## ASSESSMENT REPORT

### Section 96(1A) Modification LOT 3 HORSLEY DRIVE BUSSINESS PARK (SSD 7917 MOD 1)

Figure 5: Proposed Warehouse Footprint

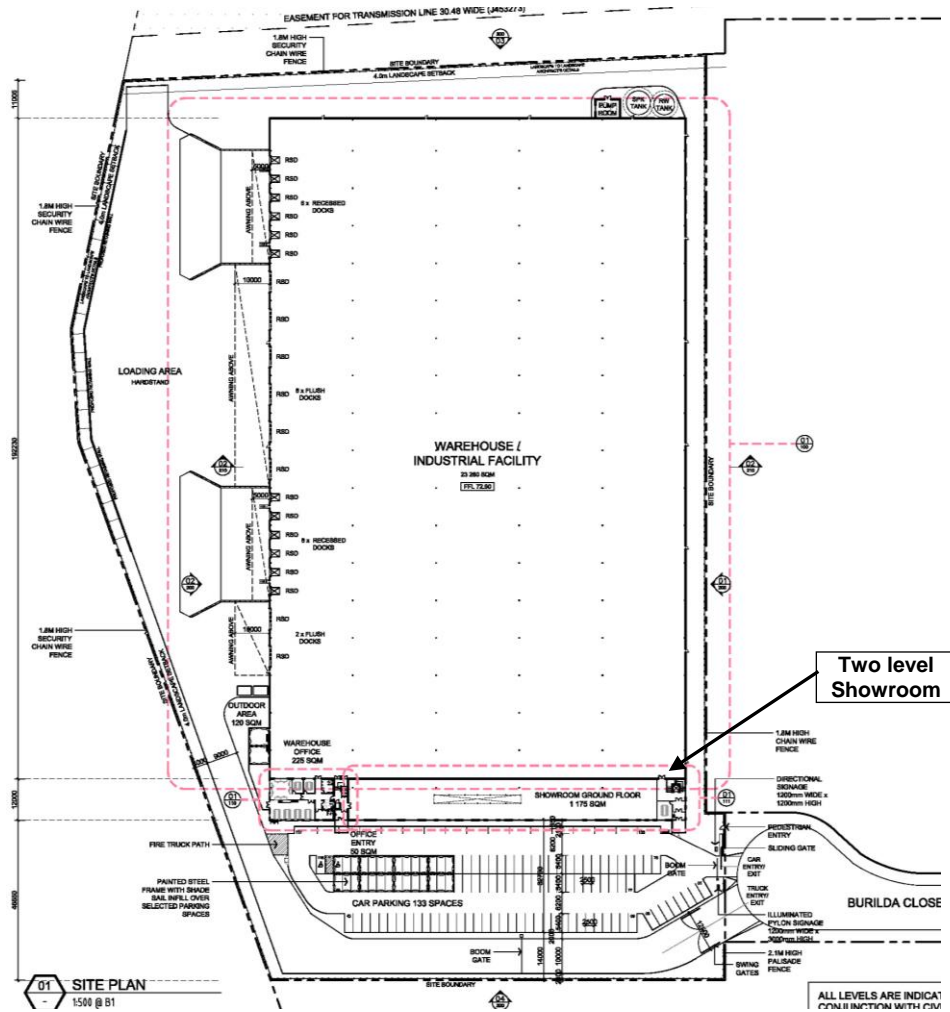
Issue	Assessment	Recommendation
<p><i>Design Excellence</i></p>	<ul style="list-style-type: none"> <li>• The modification includes alterations to the warehouse, office and showroom façade treatments as a result of the revised functional layout (see <b>Figure 5</b> and <b>Figure 6</b>).</li> <li>• The warehouse ceiling is proposed to increase in height by 1.5 m to 11.5 m. This will result in a corresponding increase in the ridgeline height of the warehouse from 12.2 m to 13.7 m.</li> <li>• The modification also aligns the eastern wall boundary of the warehouse, equating to a net GFA increase of 2,600 m<sup>2</sup>.</li> <li>• The Department considers the proposed amendments are minor in nature and concludes it would not reduce the architectural quality of the proposed consolidated warehouse building or compromise the objective of design excellence.</li> <li>• The Department accepts the Applicant's argument for the increase in height of the warehouse, noting that it would accommodate the operational needs of the future tenant.</li> <li>• The Department's considers that the increase in GFA contributes to an intensified eastern and western façade built form. However, the Department is satisfied the existing setbacks within the site and landscape treatments to the Upper Canal provide sufficient measures to screen the development from the Upper Canal.</li> <li>• The Department concludes the net GFA increase is minor and of negligible impact to that of the approved warehouse.</li> <li>• The Department concludes the proposed modification would ensure the development maintains a high standard of design and continues to achieve design excellence.</li> </ul>	<ul style="list-style-type: none"> <li>• N/A</li> </ul>
